ADDENDUM NO. 2

NORTHWEST DEVELOPMENT AREA WATER AND SANITARY SEWER IMPROVEMENTS DAYTON INTERNATIONAL AIRPORT (10% MBE Participation)

ITEM NO. 1 – Bid Set Drawing Sheets

Drawing No.
C4-1

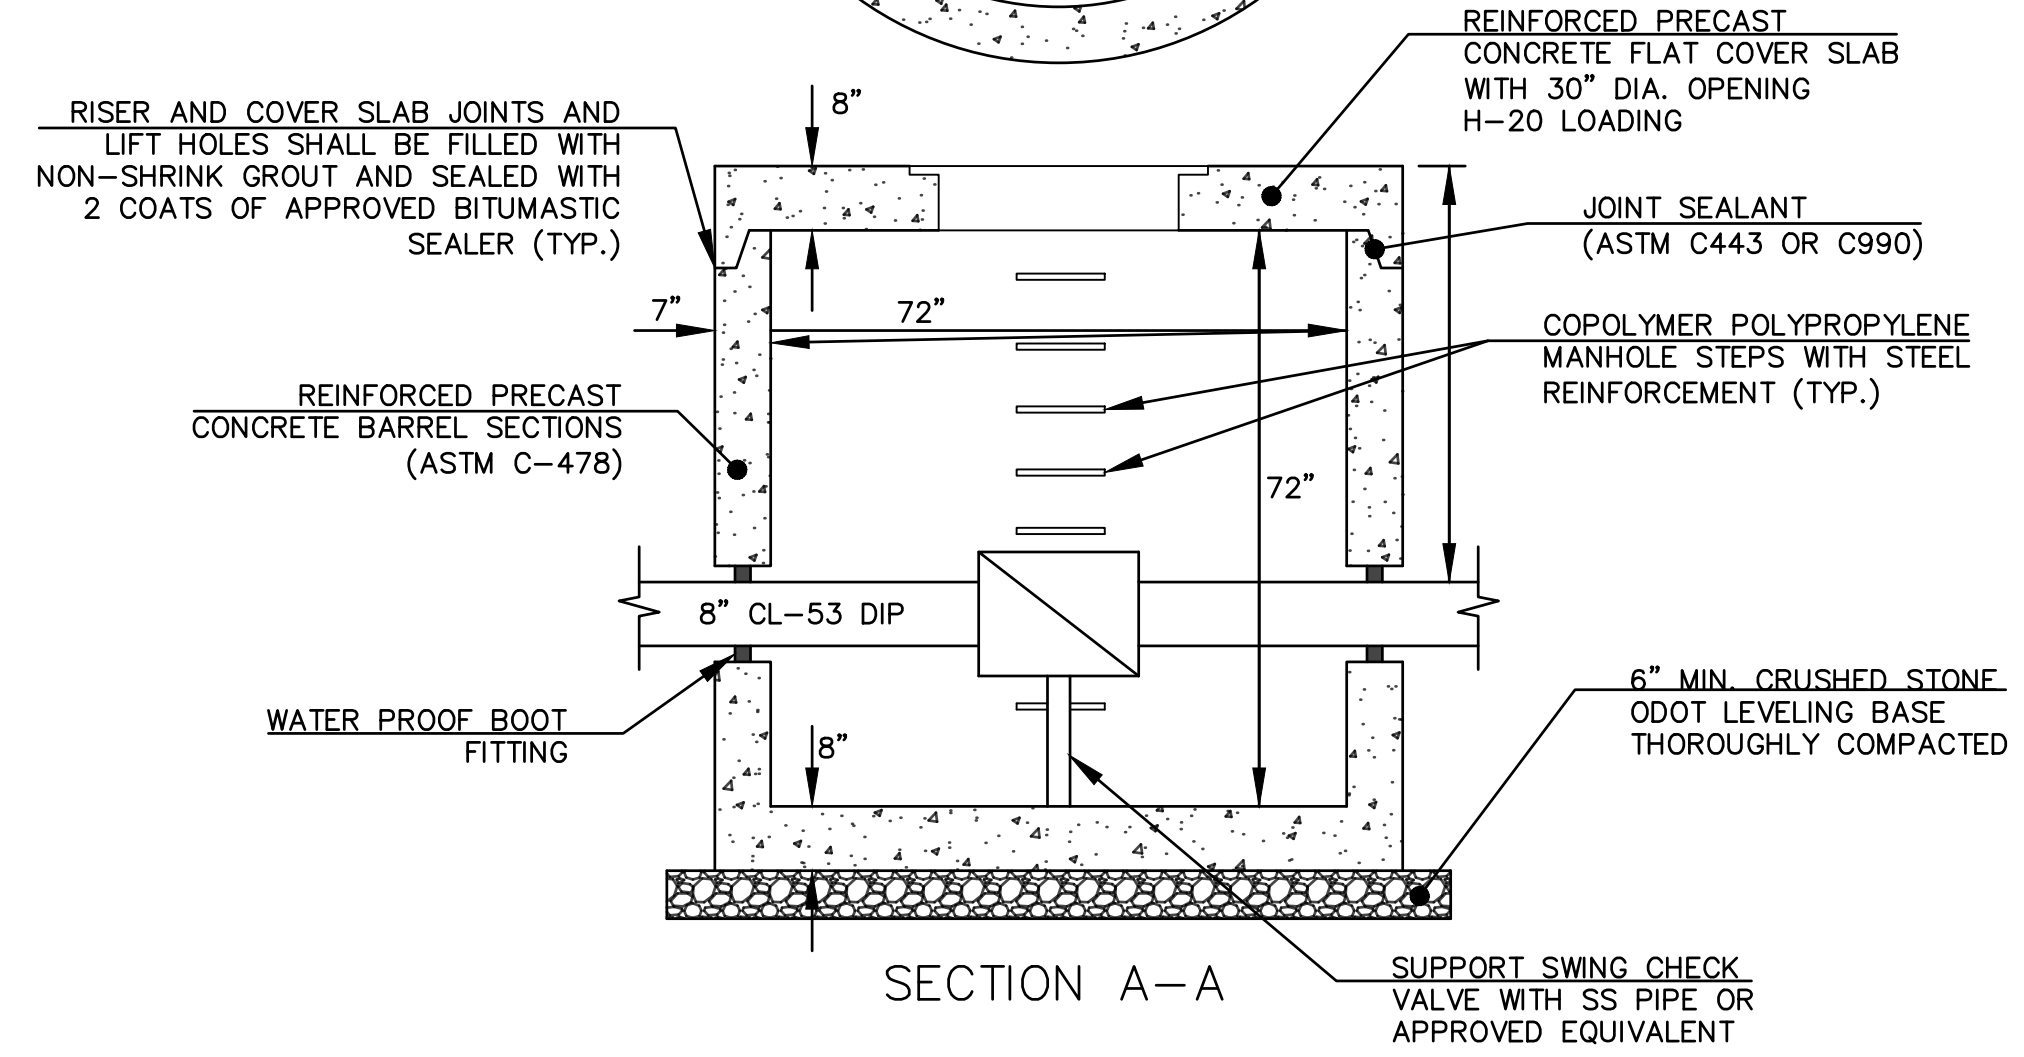
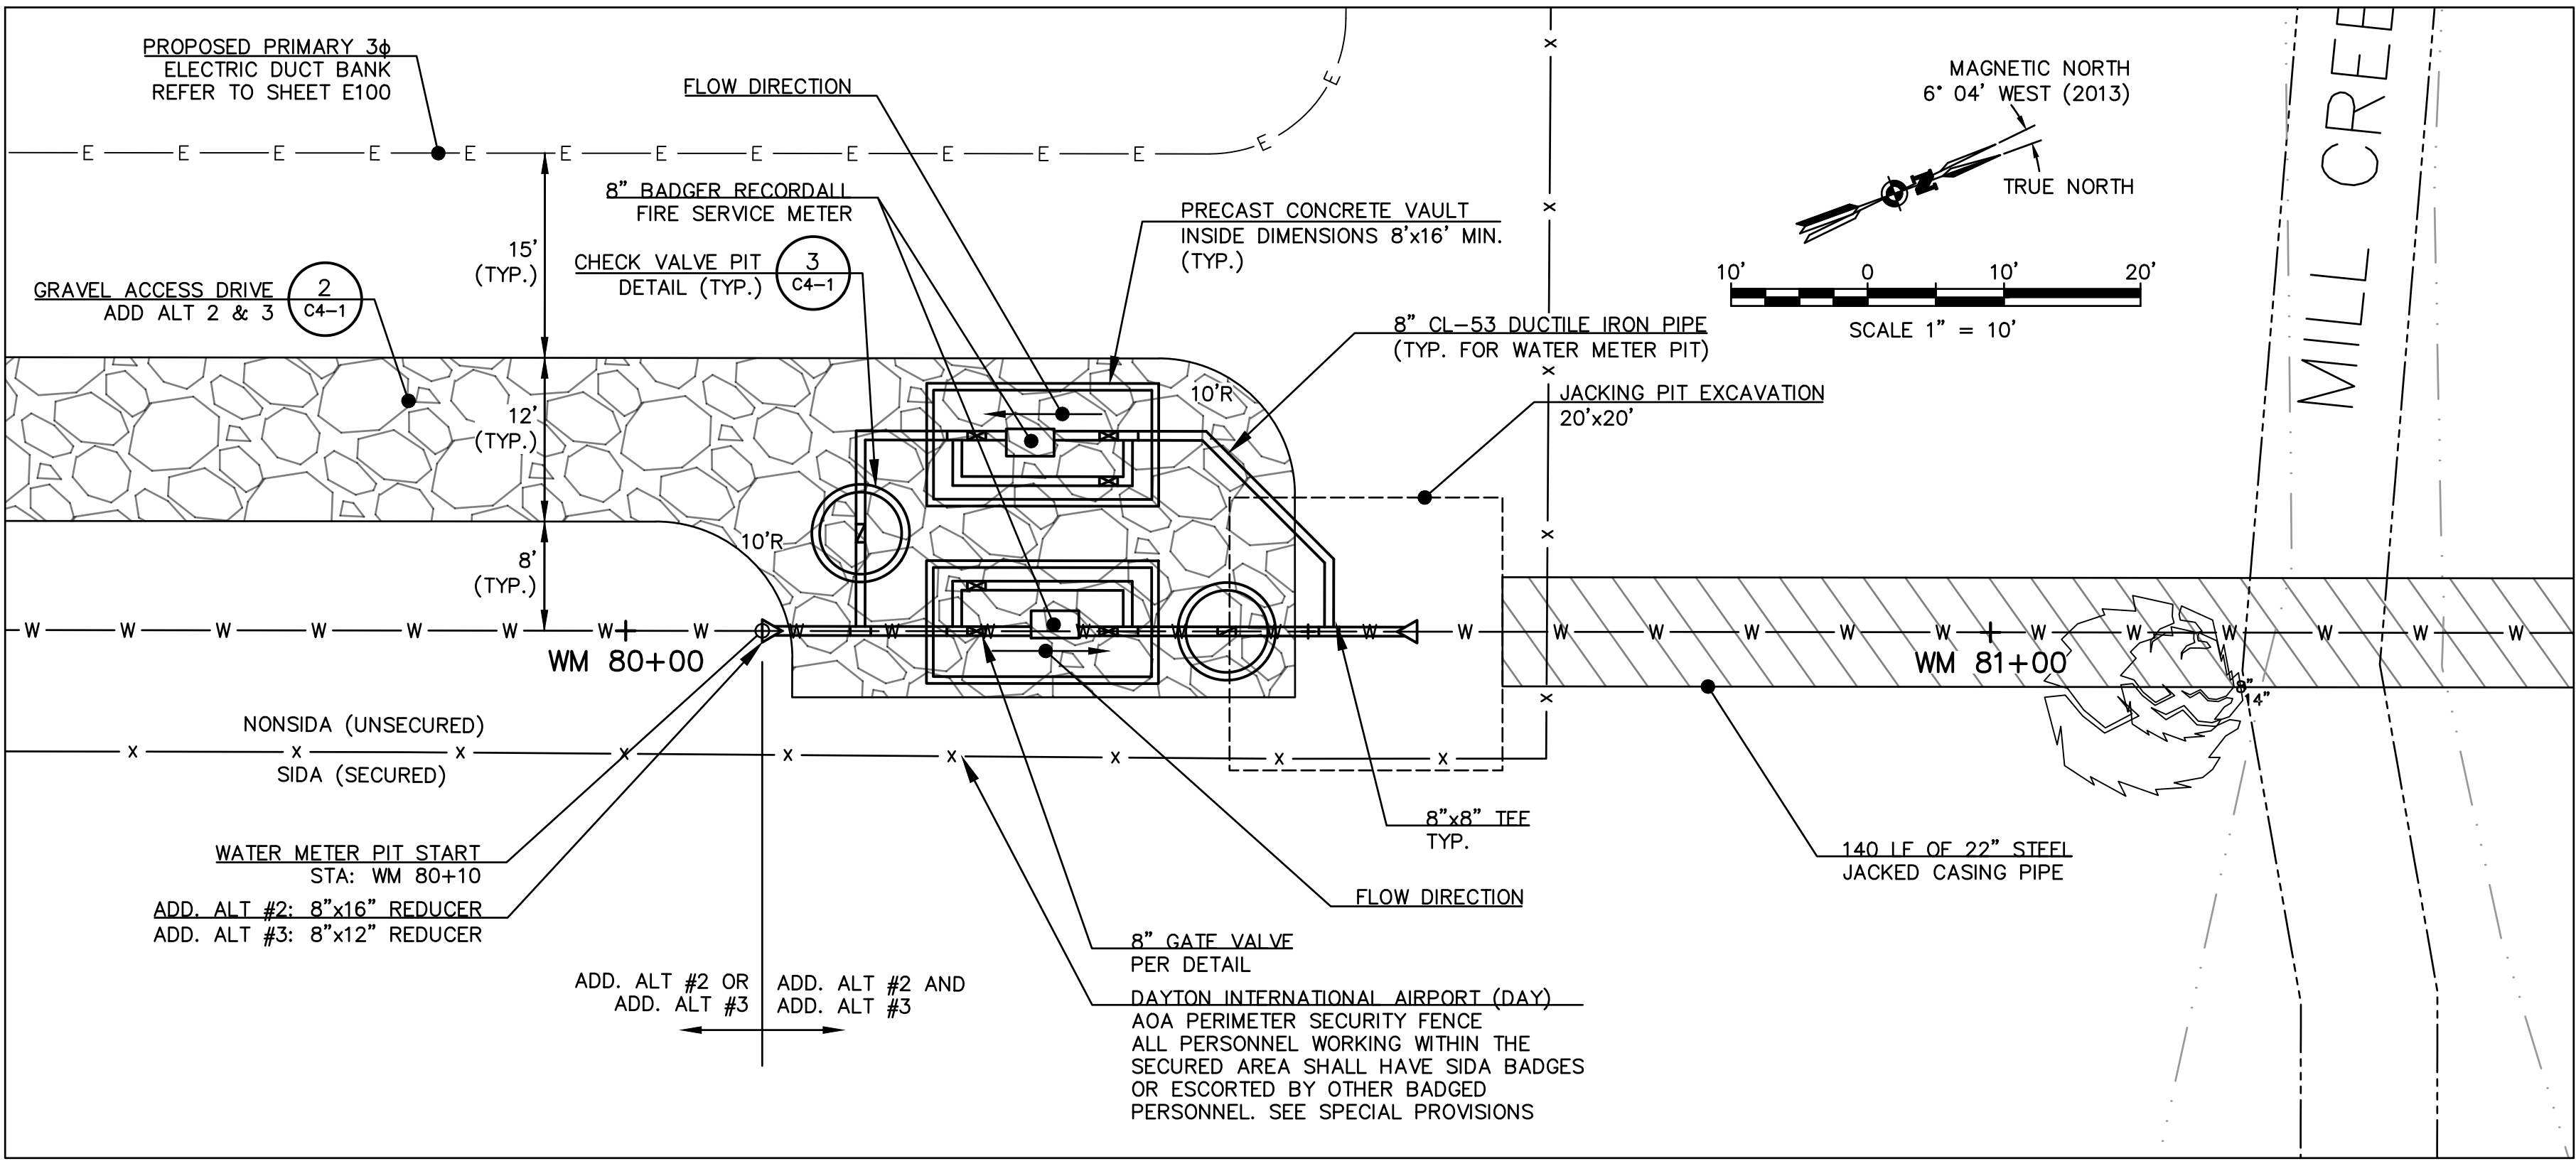
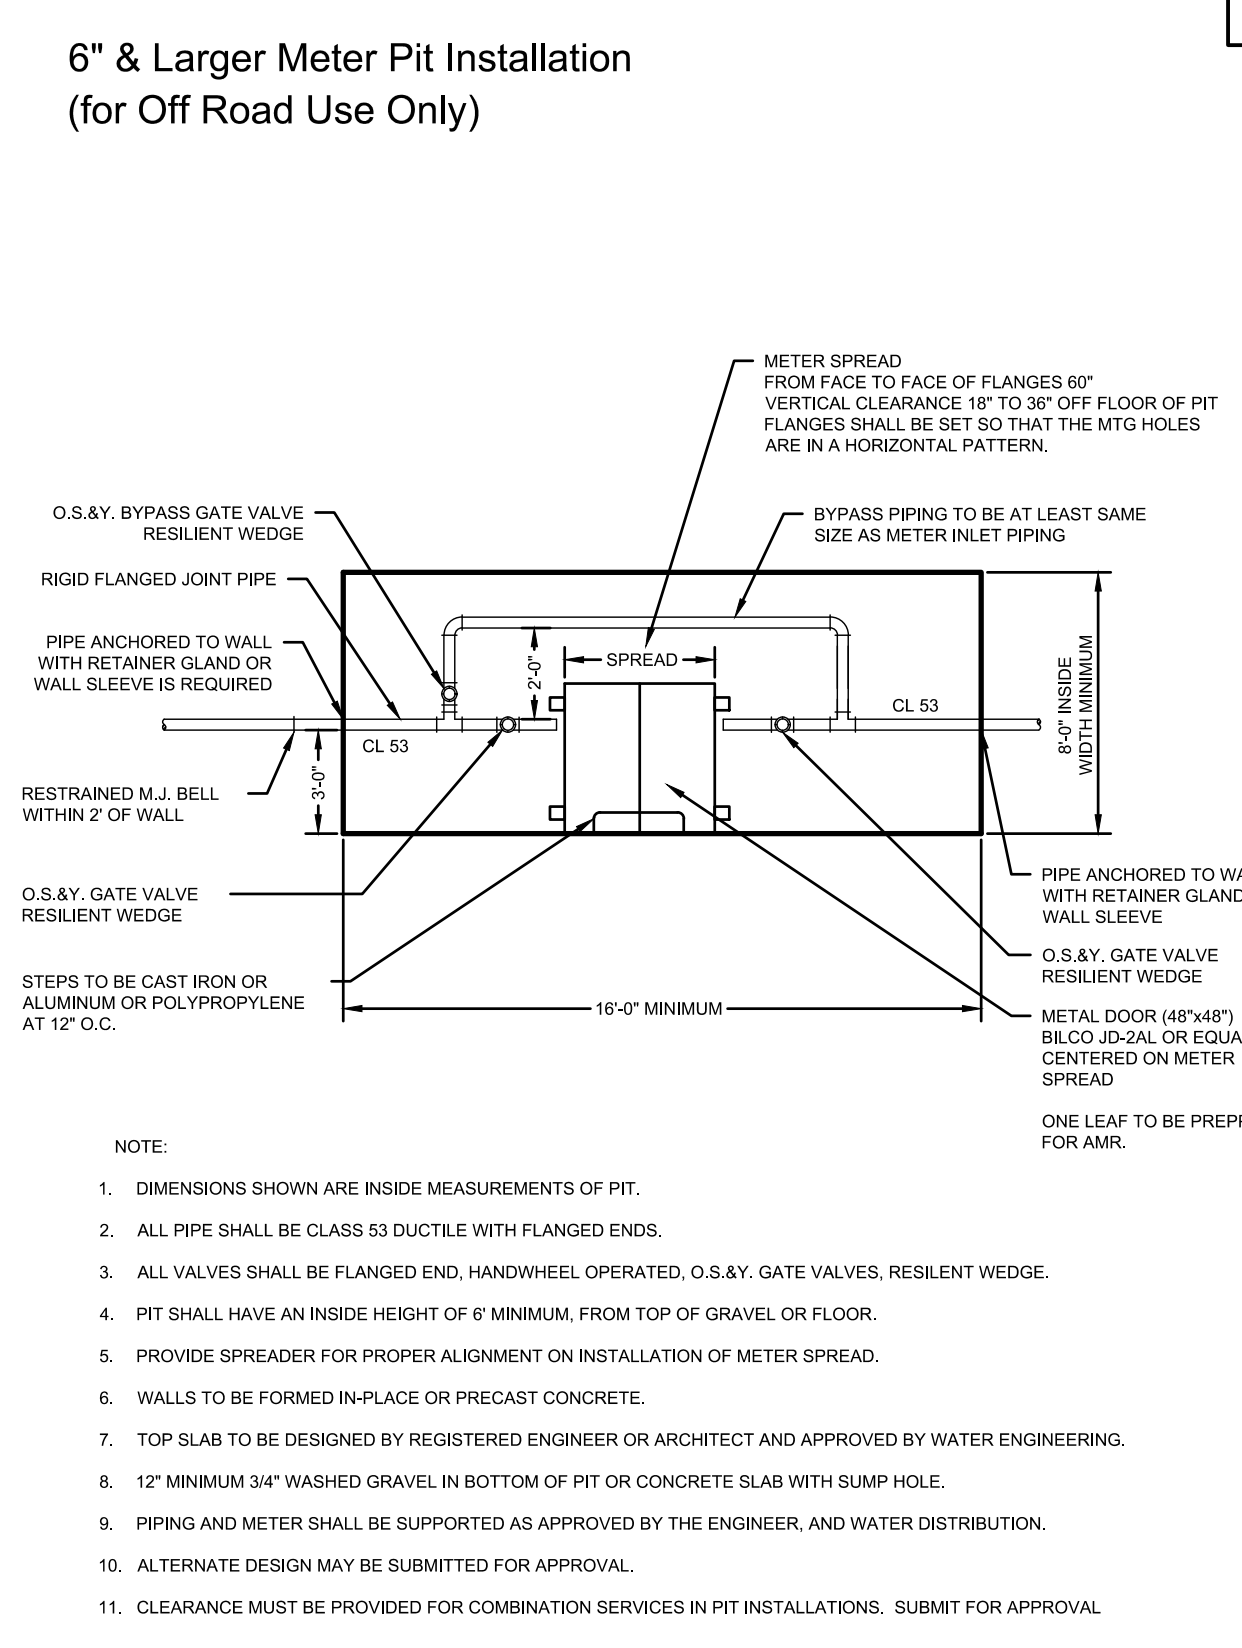
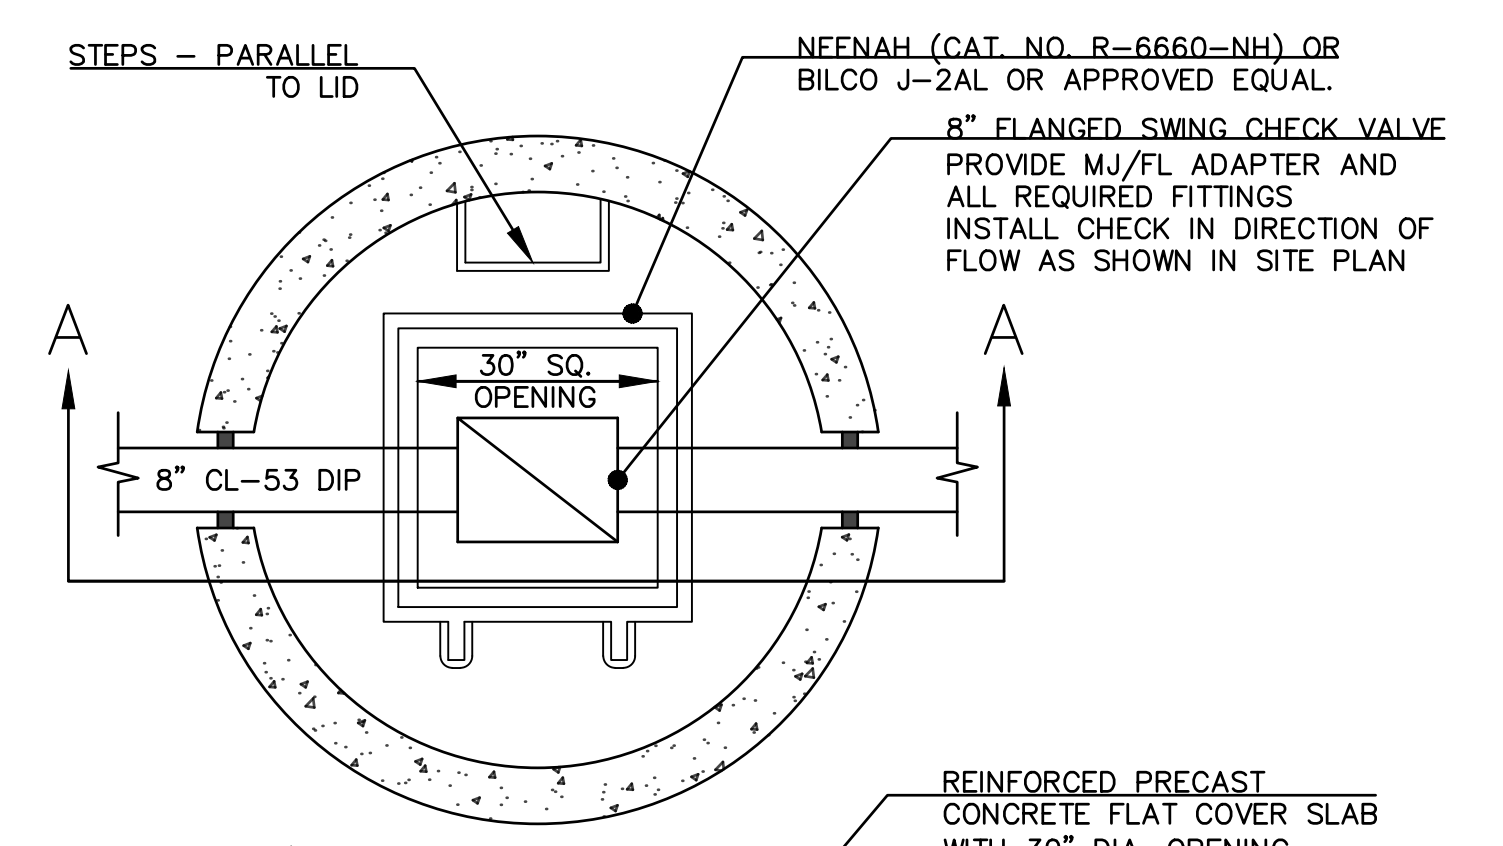
Clarification and Revise: The gravel road shown on Sheet C4-1 is for access to the meter pit. Change all references from Add. Alt #2 & #3 to Add Alt. #9.

Change: "8" Badger Recordall Fire Service Meter" to "8" Badger Recordall Combo Meter"

Change: At Sta 82+69, "Connect to Existing 12" Watermain with 12 x 12 Tee and Valve" to "12" Water Main Tapping Valve and Sleeve by City of Dayton, Contractor to Dig & Excavate"

Response: Contractor to determine the size needed to maintain the excavated PS wet well dry and suitable for construction.
4. QUESTION On alternate #9, what profile do you want on the gravel drive and how do you want it to get to the meter pit, does this show on a drawing?

Response: See Updated Bid Form
17. QUESTION The detail on C4-1 check valve pit. Can you detail that a little, the detail does not appear to support the intended check valve, is it an 8" check valve?

Response: See item No. 1 Revised Drawings. Gravel drive is to be profiled in such a way to drain water away from road and the pit. Construct at least 2" below top of pit.

Response: See Revised Detail
